Development / Project Name	1st Ave Residences
Development / Project Address	<u>Existing:</u> 117 SW 5 St., 417 SW 1 Ave., and <u>New:</u> 477 SW 1st Avenue 430 S Flagler Avenue
Legal Description	Parcel A and B, Mercury Plat, according to the plat thereof as recorded in Plat Book 154, page 40 of the public records of Broward County, Florida
Tax ID Folio Numbers (For all parcels in development)	5042101H0010 and 504210013950
Request / Description of Project	Site plan approval for 380 units with 2,700 sq ft retail Allocation of 380 flex units from Flex Zone 54
Total Estimated Cost of Project	\$ (Including land costs)

PRELIMINARY DESIGN FOR:
1ST AVENUE RESIDENCES
FORT LAUDERDALE, FLORIDA

DEVELOPMENT REVIEW COMMITTEE (DRC) COMMENT REPORT

Request: Site Plan Level II Review: 380 Multifamily Units,
Parking Garage, 2700sf Retail Use

EAST ELEVATION

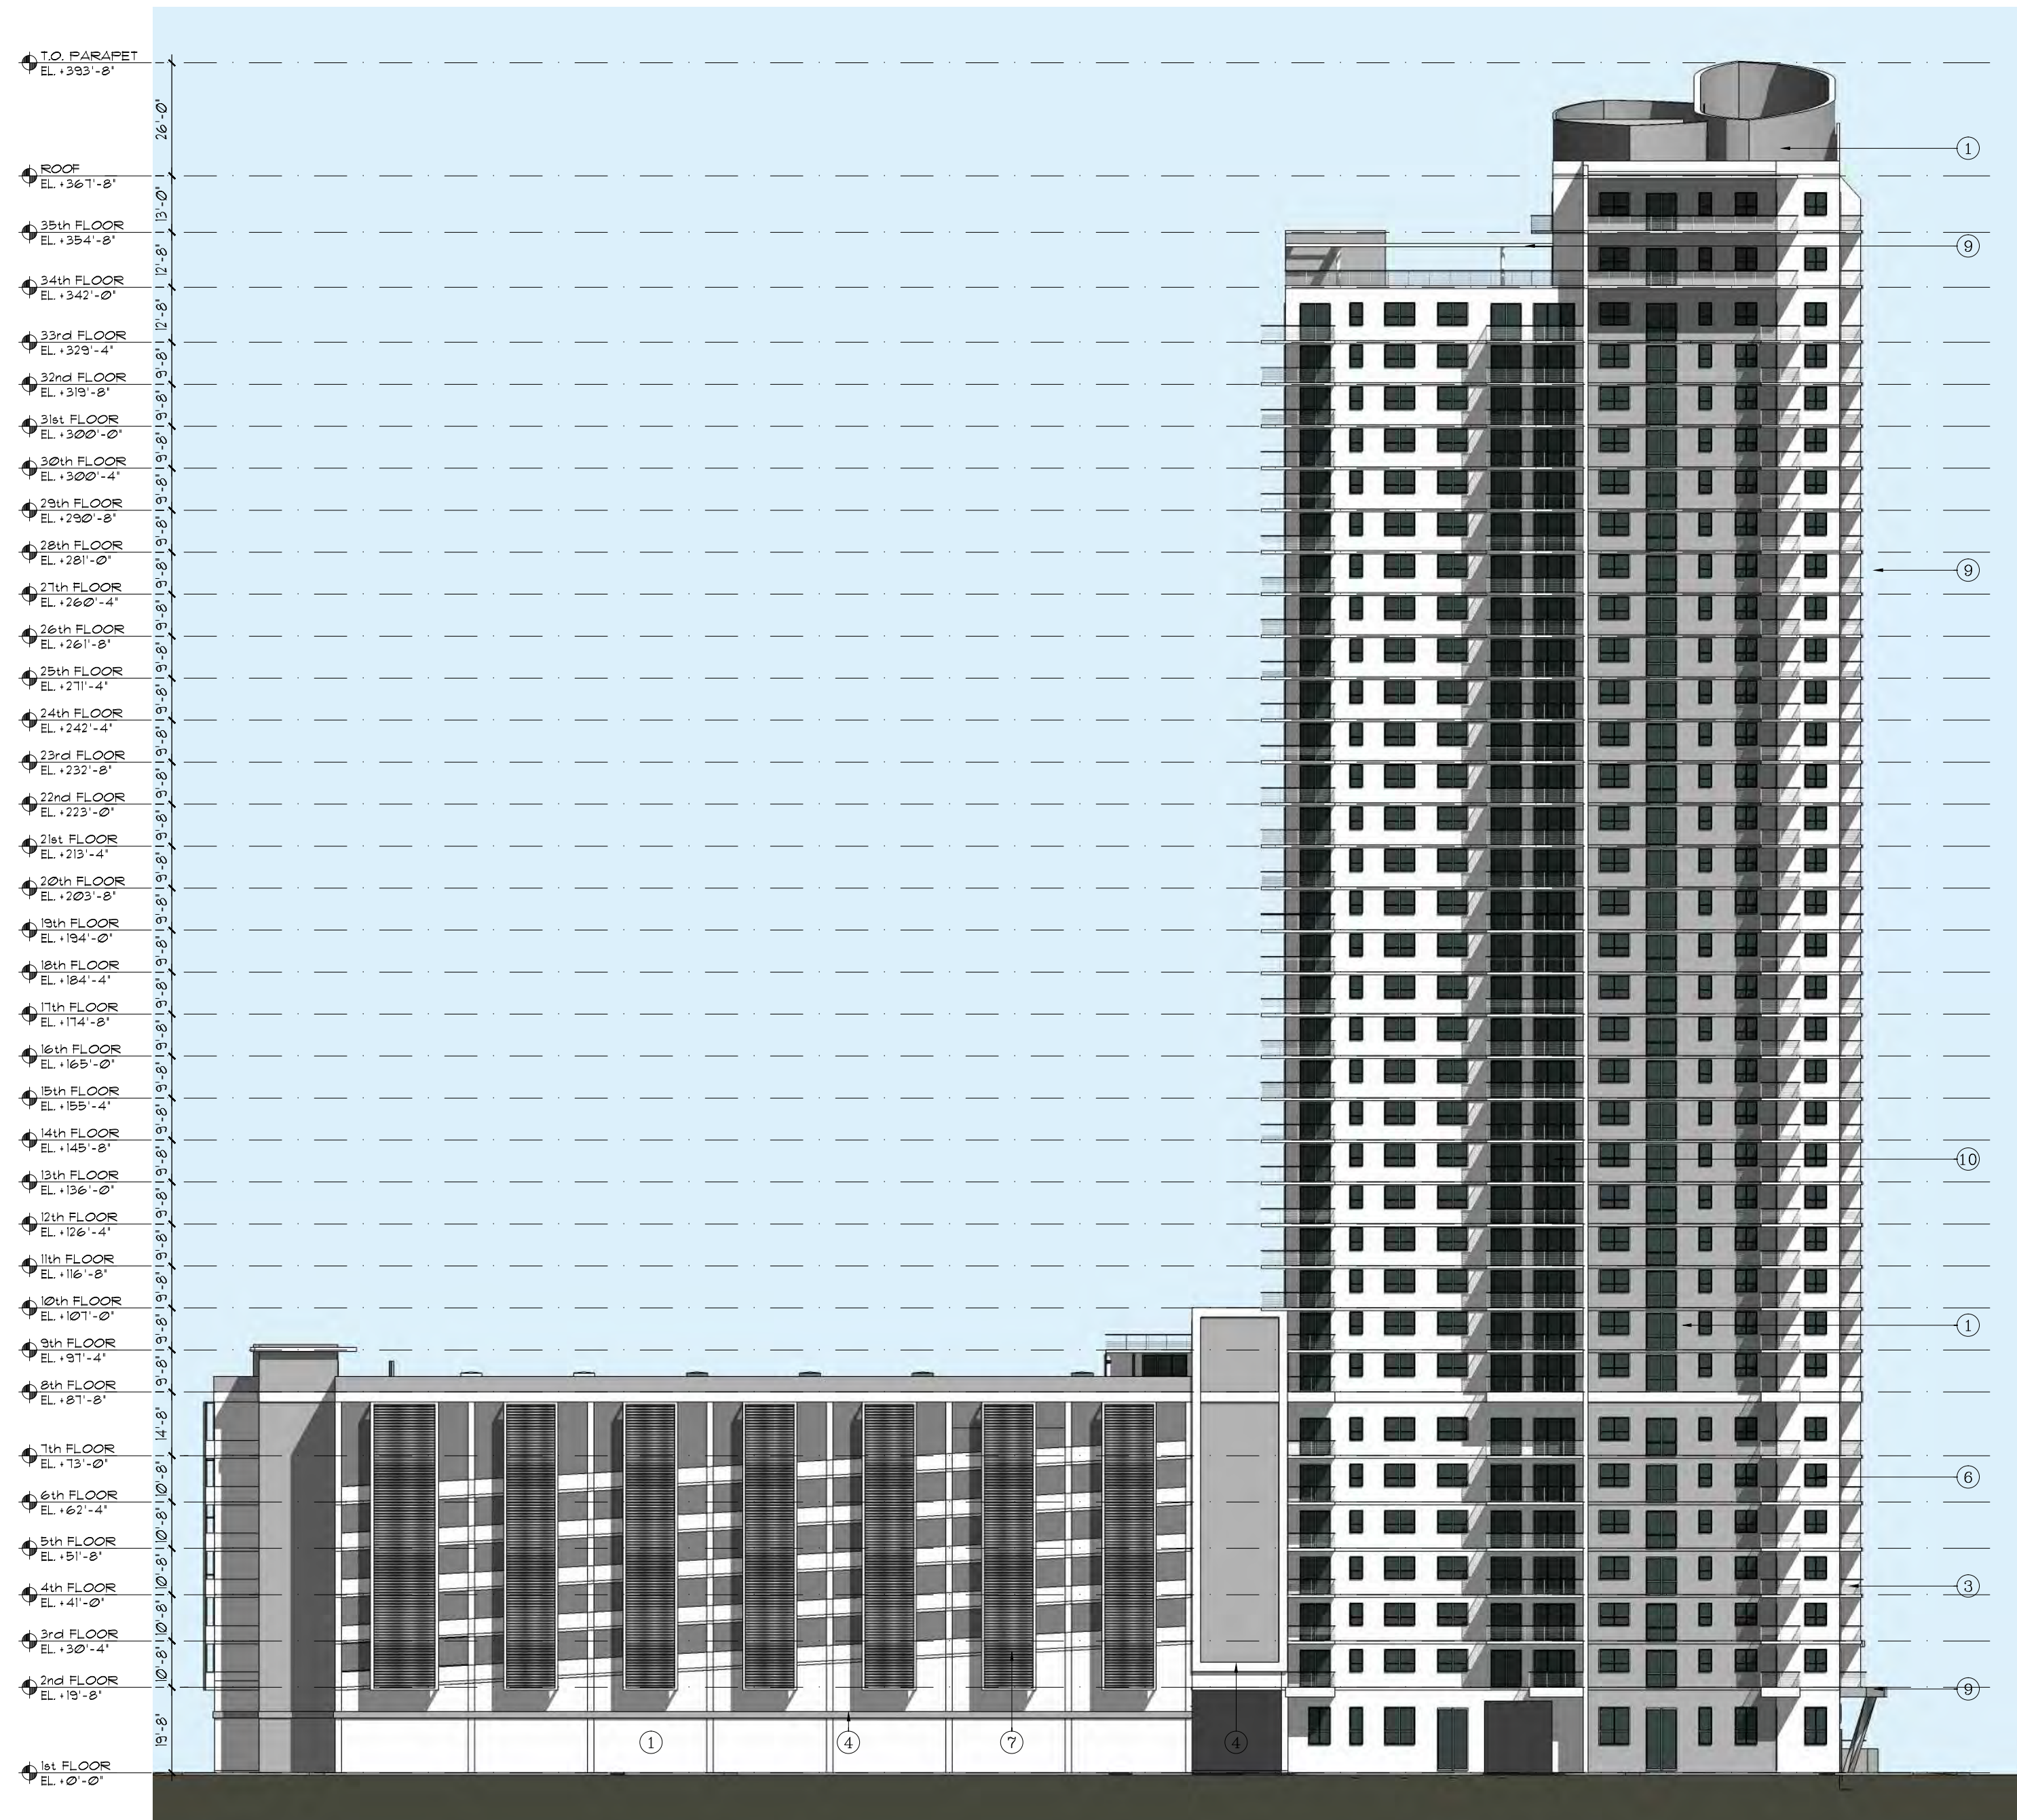
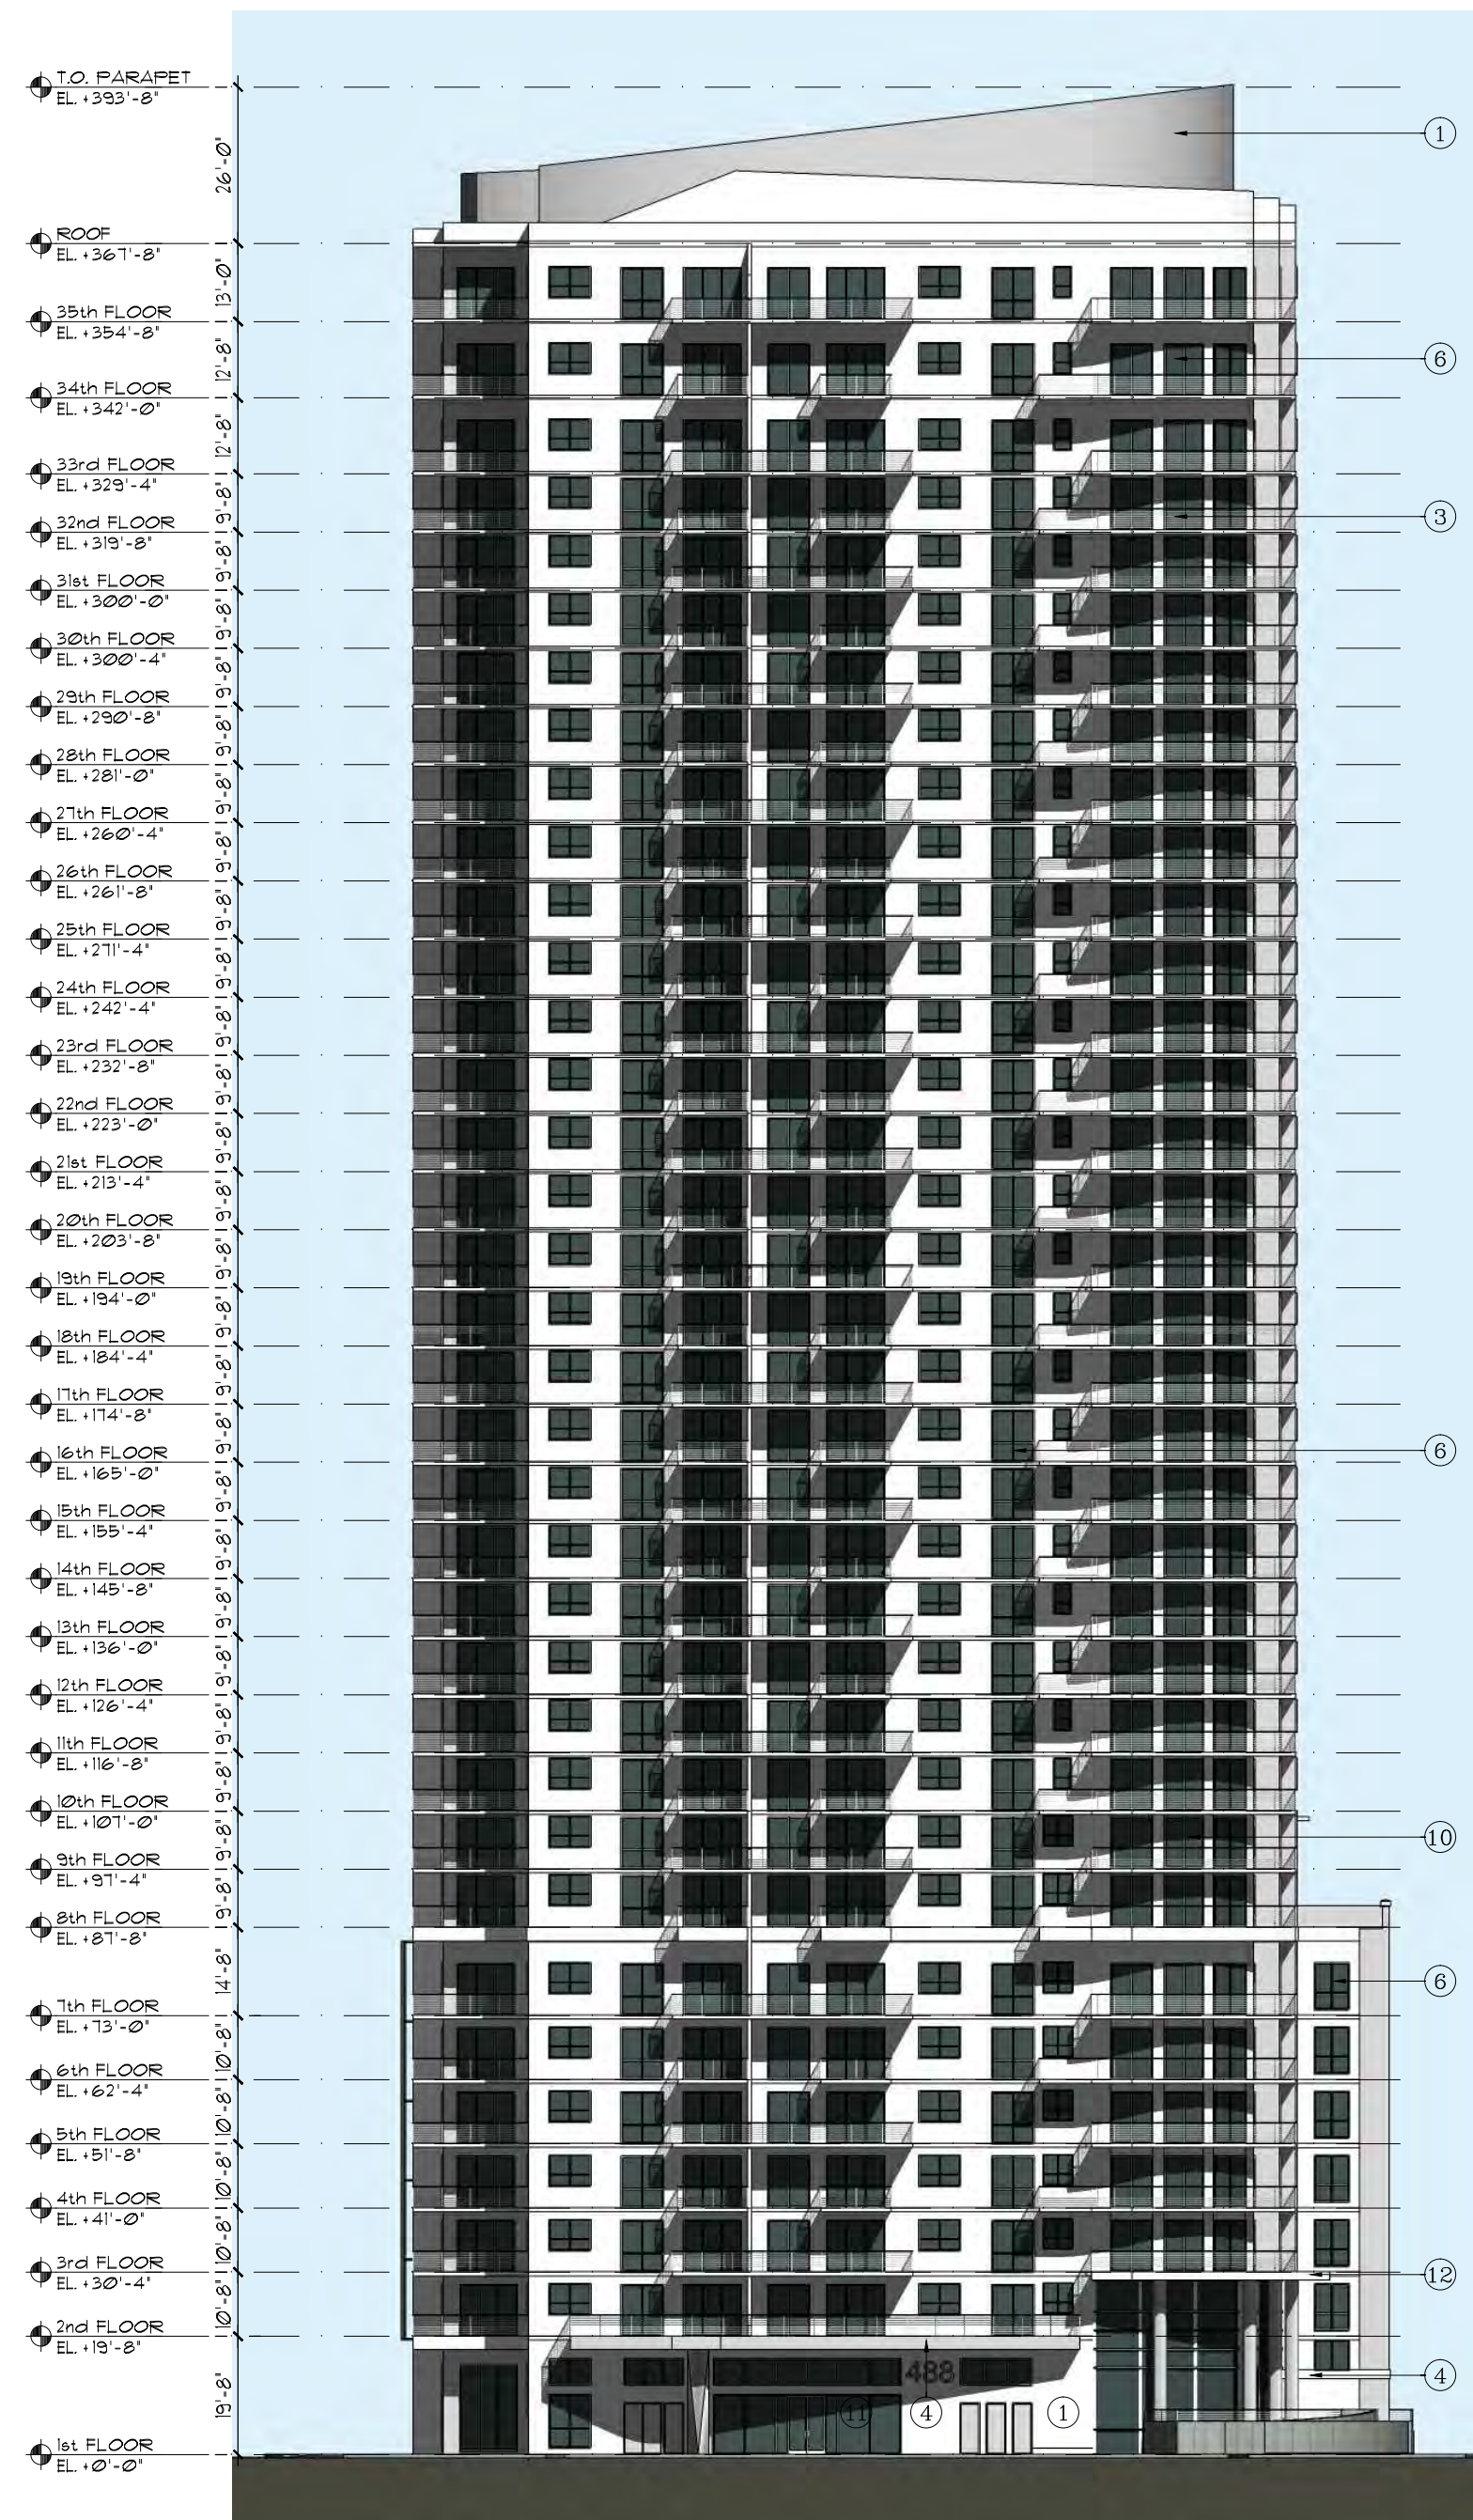
20. Show and callout delineations for proposed Right-of-Way Easement boundaries on the Site Plan and the Civil drawings. On Sheet A4.0 thru A5.0 (3 Sheets), show and label existing Right-of-Way and proposed Right-of-Way Easement boundaries on all building elevation details.
